**TOWN OF BROOKLYN
PLANNING AND ZONING COMMISSION
Regular Meeting Agenda
Tuesday, November 17, 2020
6:30 p.m.**

SUBJECT: Proposed Parking Expansion
Vachon Chevrolet
Assessor's Map 41, Lot Nos. 13A & 14
Providence Road (Route 6)
Brooklyn, Connecticut

ENGINEERING PLAN REVIEW PERTAINING TO PROPOSED PARKING EXPANSION VACHON CHEVROLET (ASSESSOR'S MAP 41, LOTS 13A & 14) PROVIDENCE ROAD (ROUTE 6) BROOKLYN, CT (March 20, 2020)

IMPROVEMENT LOCATION SURVEY
SITE DEVELOPMENT PLAN No. 1
PREPARED FOR
VACHON BROOKLYN, LLC
512 PROVIDENCE ROAD (ROUTE 6)
BROOKLYN, CONNECTICUT

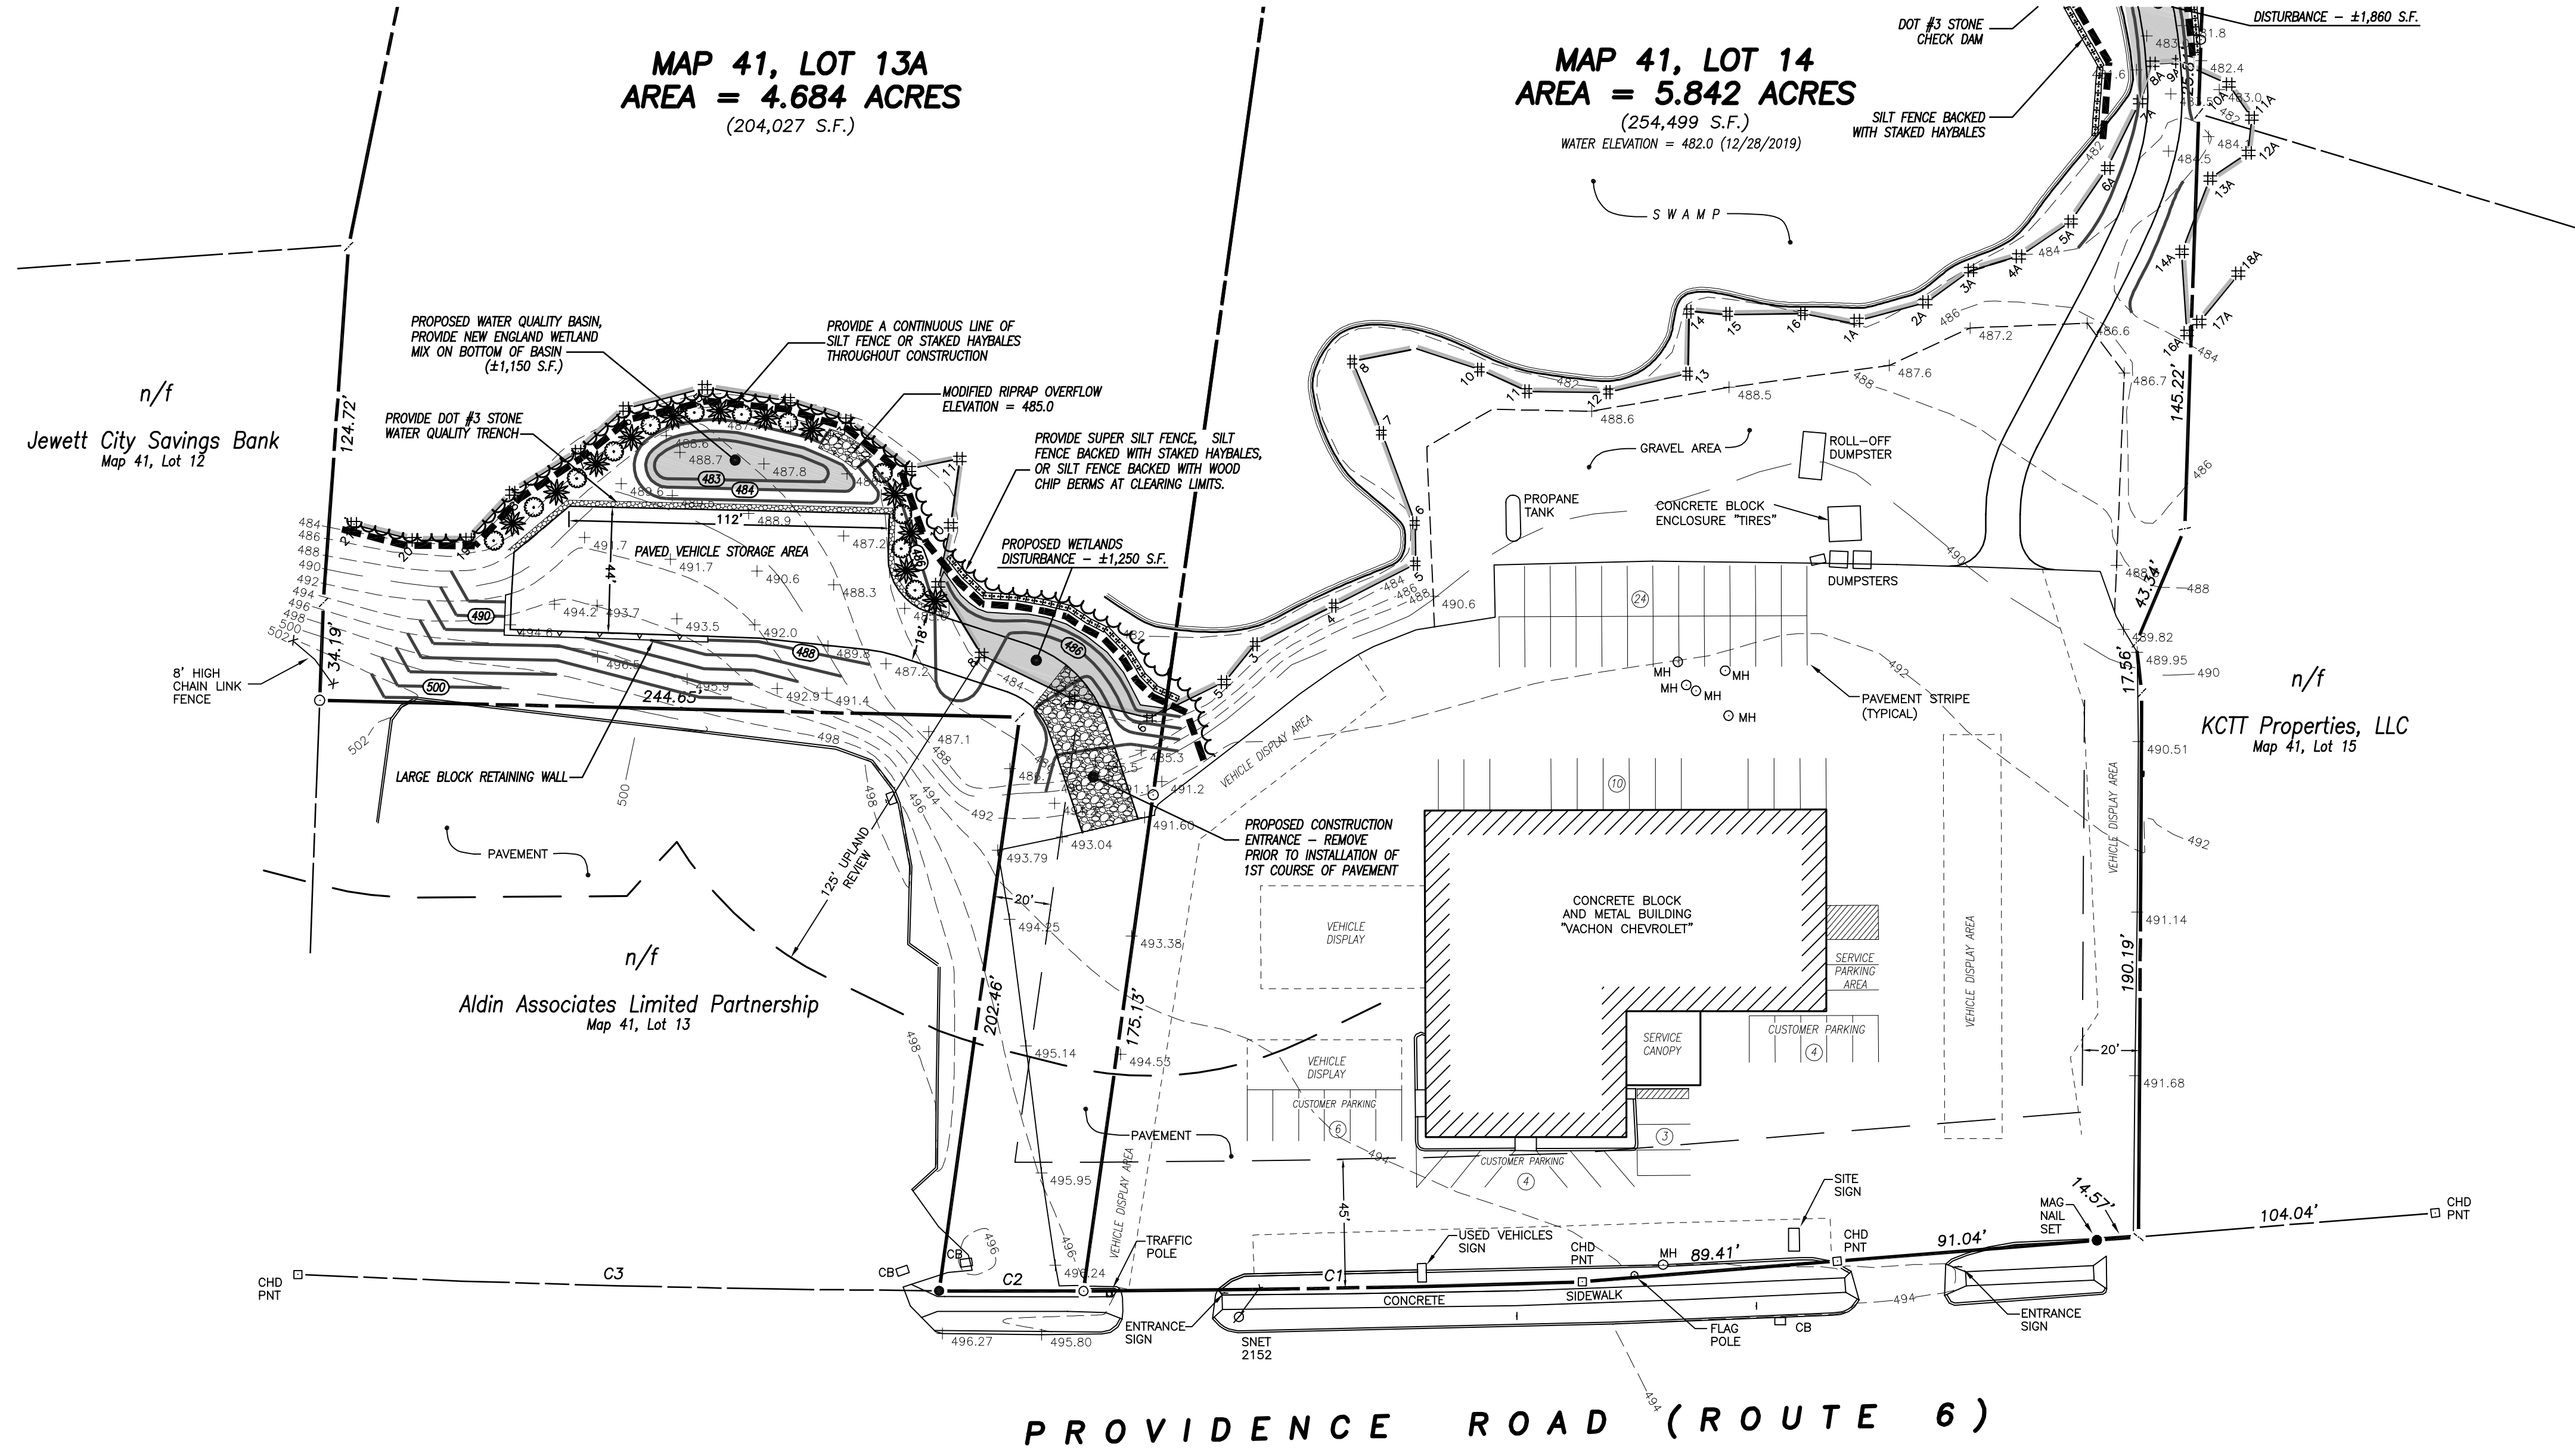
SHEET 3 OF 5 – SITE DEVELOPMENT PLAN NO. 1

1. A construction entrance symbol is drawn at the entrance to the new "paved vehicle storage area." However, a note should be included to indicate that this will be removed at the time the first course of paving is installed for the vehicle storage area. Additionally, it would be helpful for this explanation to be included in Note 17 under "Development Schedule/Sequence of Operations" that appears on Sheet 5 of 5 of the plan set.
2. The note "Silt Fence Backed with Staked Haybales or Wood Chip Berms" should read the same as the note on Sheet 4 of 5, "Provide Super Silt Fence, Silt Fence Backed with Staked Haybales, or Silt Fence Backed with Wood Chip Berms at Clearing Limits," for consistency.

Sheet 3 of 5 – Site Development Plan No. 1

1. A note has been added to the plan to direct the contractor to remove the anti-tracking construction entrance prior to installing the first course of pavement. This has also been noted on sheet 5 of 5 in the development schedule/sequence of operations.
2. The note "silt fence backed with staked haybales or wood chip berms" has been modified to read the same on all sheets.

DATE: 1/07/2020	DRAWN: AMR
SCALE: 1" = 40'	DESIGN: NET
SHEET: 4 OF 5	CHK BY: ---
DWG. No: CLIENT FILE	JOB No: 19129

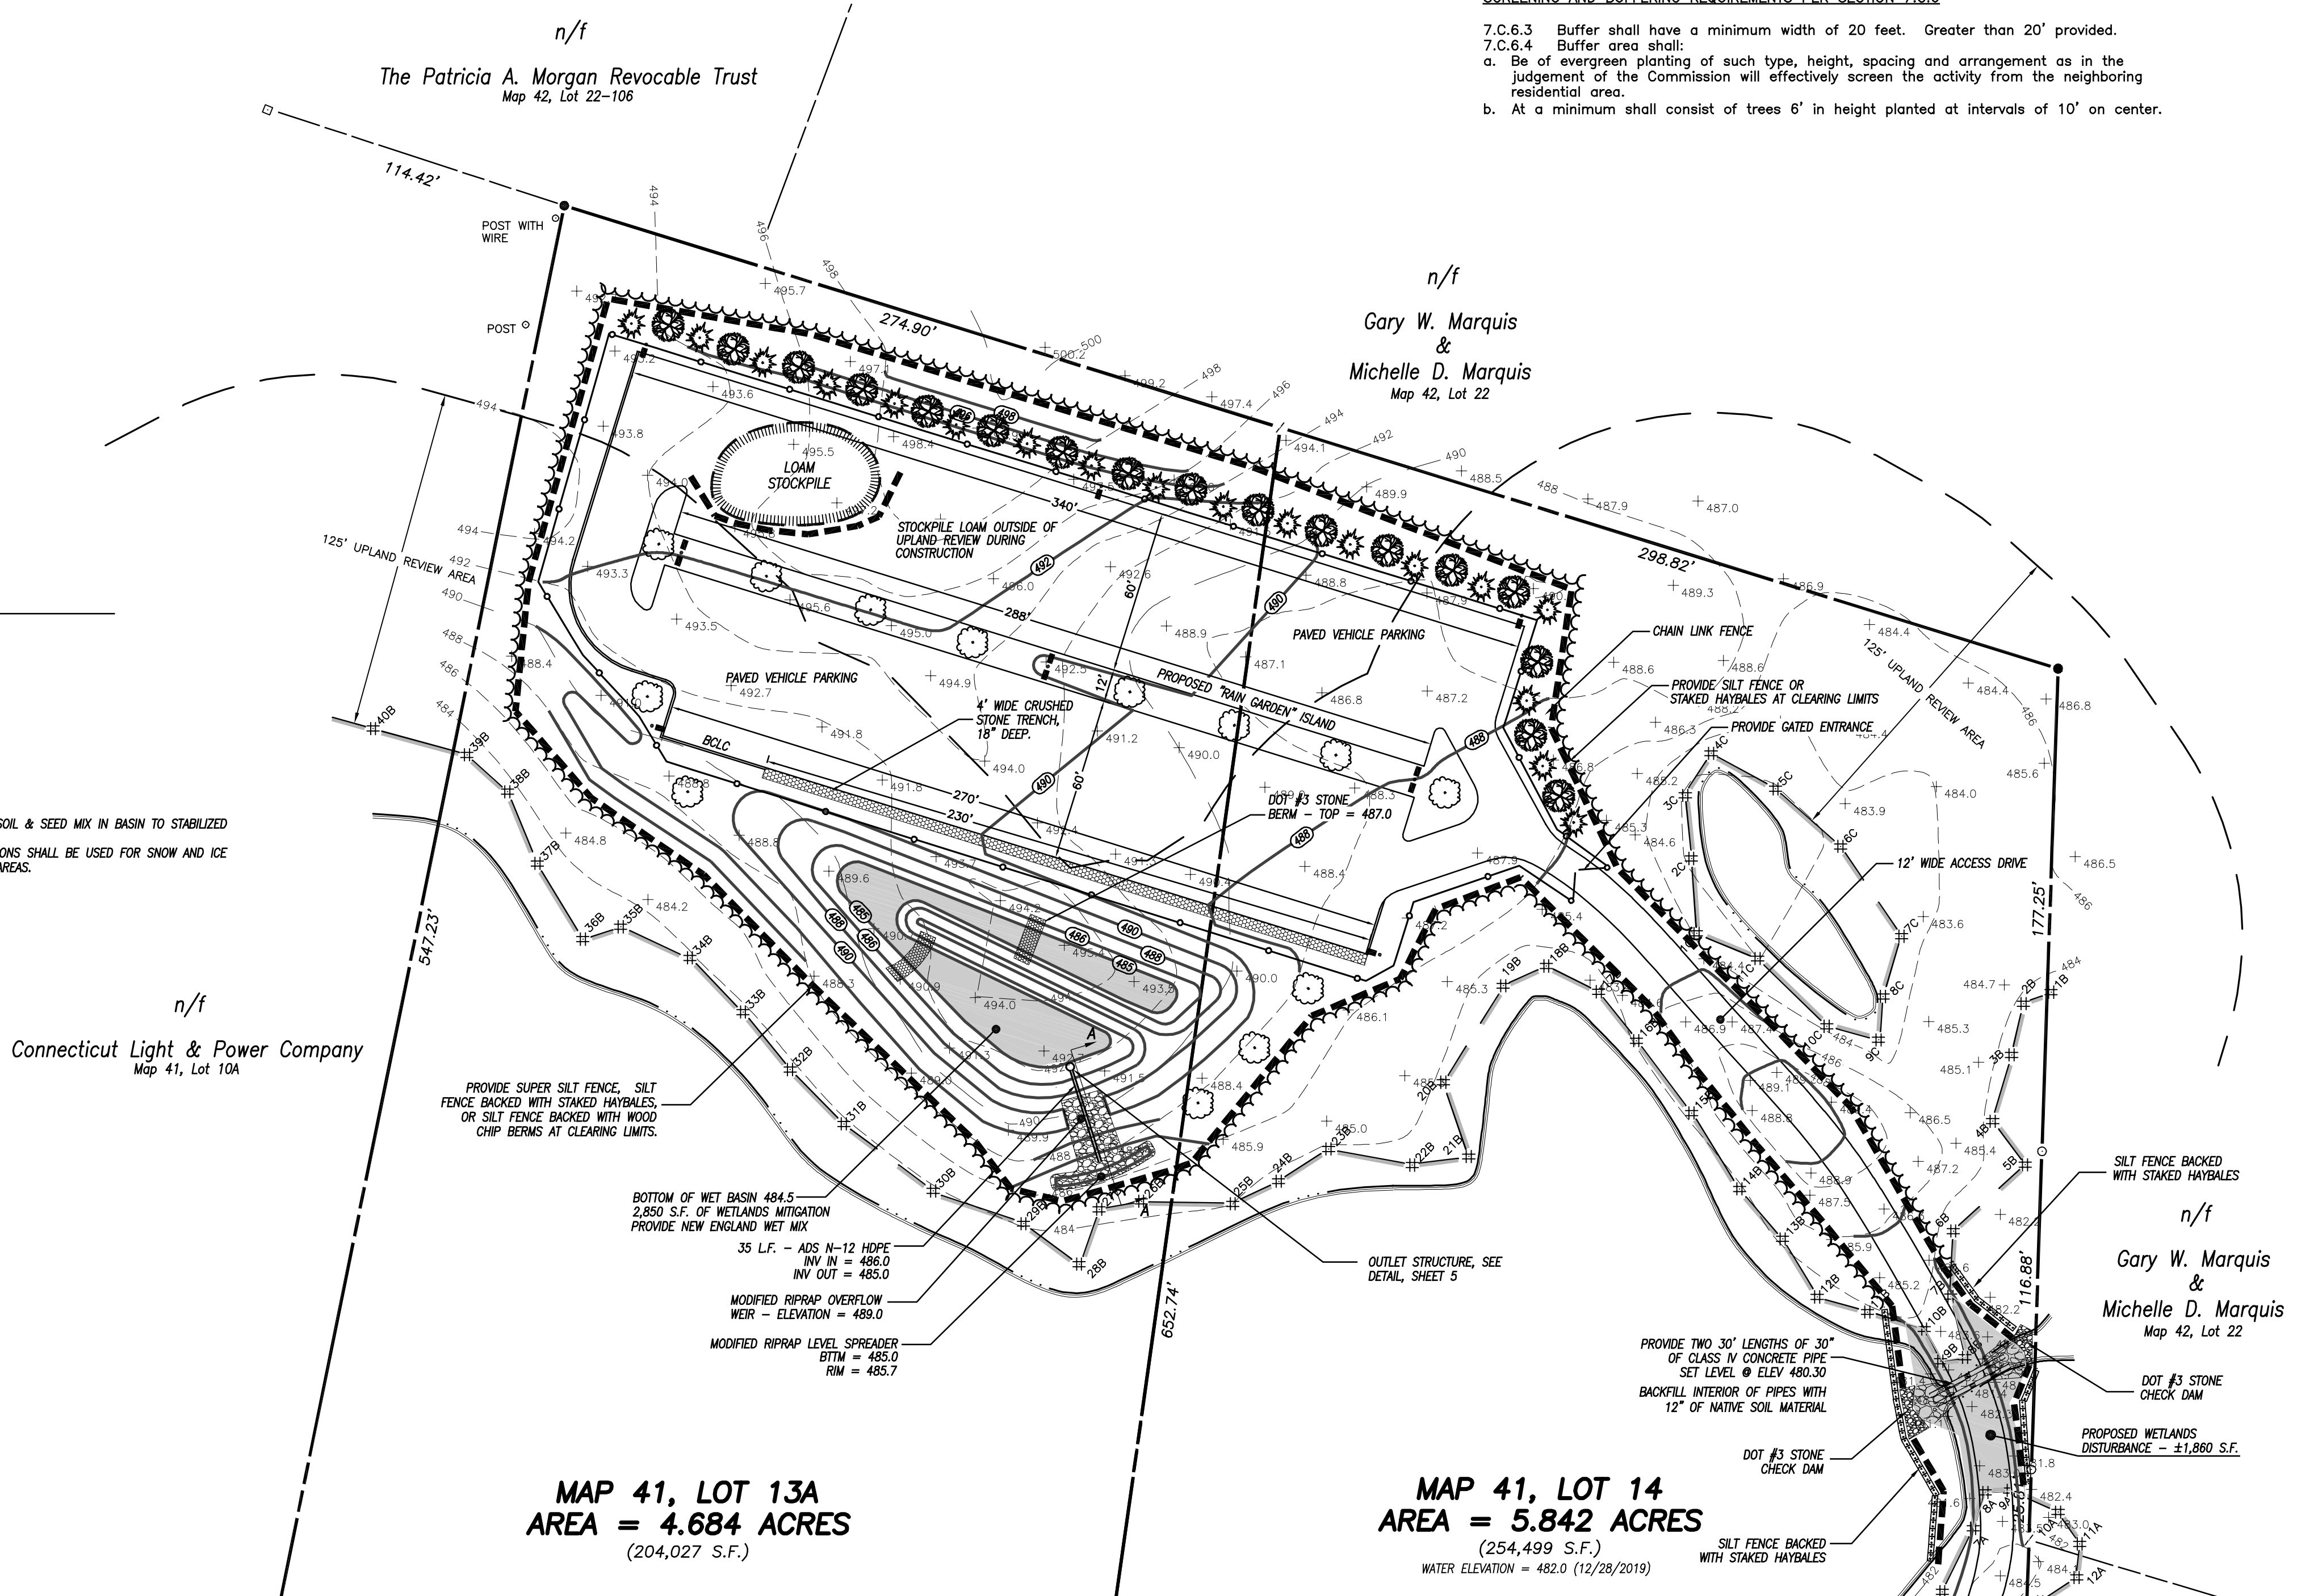
SHEET 4 OF 5 – SITE DEVELOPMENT PLAN NO. 2

1. Proposed slopes in the detention basin range from 1:1 to 3:1. It is recommended that slope be uniform and that no slopes be steeper than 3:1 to reduce the tendency of soil erosion
2. Pedestal lighting, with dual light fixtures, is shown at three (3) locations in the middle of the proposed vehicle parking area. No description of the lighting assembly (pedestal height, pedestal base, full cutoff design, wattage, etc.) can be found in the plans under review. This is important since there is a house on adjacent Lot No. 22 that is not too distant from the north property line in the vicinity of the proposed construction on the Vachon property. It should also be noted that the

majority of the visual/sound barrier created by the existing mature forest in this area between the house and the proposed development is going to be removed, only to be replaced by young plantings that will take many years to reestablish the buffer. Therefore, has the impact of lighting and noise on the adjacent residence been evaluated to determine if there will be any significant impact to it?

3. How will snow removal be handled in this area so as not to impact the adjacent wetlands (salt or other ice removal chemicals) and proposed landscaping?
4. It is unclear on how the "island" in the middle of the proposed parking area is going to be constructed, i.e., raised island with landscaping; raised island paved with no landscaping; flush with whatever in between; etc.? Can this area be used as a rain garden to mitigate some of the runoff from the pavement?
5. Is there any consideration to provide some form of "tall" landscaping in the center island, considering how much impervious pavement is being proposed?
6. As an aid to construction, it would be helpful to include a cross-section profile from the detention basin outlet structure to just beyond the level spreader.

Sheet 4 of 5 – Site Development Plan No. 2

1. Slopes in the detention basin have been modified so that they do not exceed 2:1 (center berm only). We have also noted that jute netting shall be installed to stabilize the basin after topsoil and seed have been applied. The center berm is designed to extend detention time in the basin and we do not anticipate erosive conditions once stabilized.

2. A detail for the lighting fixture with the make and model number has been added to the plans. We have also enclosed a cut sheet for the lighting as well. The chosen fixtures will be mounted no higher than 12' and are dark sky compliant. In addition, the landscaping proposed between the parking and the residences to the north will provide a very good vegetated buffer; cut sheets for the chosen plantings is included with this submission. Currently, the existing pine trees do not provide any visual buffer. As with most larger pine trees, there are minimal branches at the bottoms of the trees up to 20' or more. With regard to noise, this area will be utilized to store inventory and will not be accessed by the general public unless accompanied by a sales representative.

3. Snow will be stockpiled at the top of the slope adjacent to the proposed stormwater basin. Sheet 5 of the plans specify that no salt or chemical applications for snow removal shall be used.

4. The island in the center of the site will be depressed. We will incorporate rain garden plantings into the island to promote stormwater treatment and infiltration.
5. As the center island will be utilized in the capacity of a rain garden, we do feel that taller vegetation would be appropriate.
6. A cross section of the basin outlet has been added to the plans as requested.
